Subject: RE: PL/2023/09142 Fw: moto J16 M4 outstanding matters (Landscaping Matters)

I have looked at the draft revised submissions and provide comment in relation to previous highlighted issues supporting a reason to object to this proposal raised in my consultation response dated 12/12/2023 as follows....

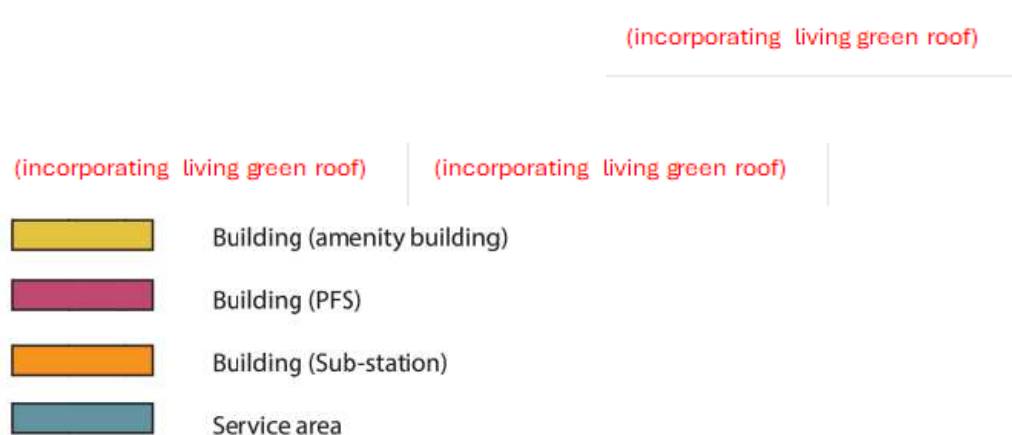
I enclose a screenshot image from Google maps below which potentially illustrates how ineffective the currently proposed 2-metre-high northern boundary fence would likely be to achieve the required screening function for motorway traffic (note the existing timber post and rail fence running along the edge of the northern site boundary is circa. 1.2 metres high) given the existing level differences between elevated M4 slip road traffic and application site levels. This could represent a challenge for the applicant when seeking to discharge any associated condition requested/required by the Highways Authority. In my opinion the only way this could be realistically addressed would be to construct earth bunds parallel to the motorway and plant these up to provide long-term screening or construct a very high screening fence? Whether National Highways comments only relate to the Main Carriageway (more level with the site) and not the elevated west bound slip road may be a matter the applicant / LPA should clarify? This issue could significantly impact the amount of development that could be achieved within the site.
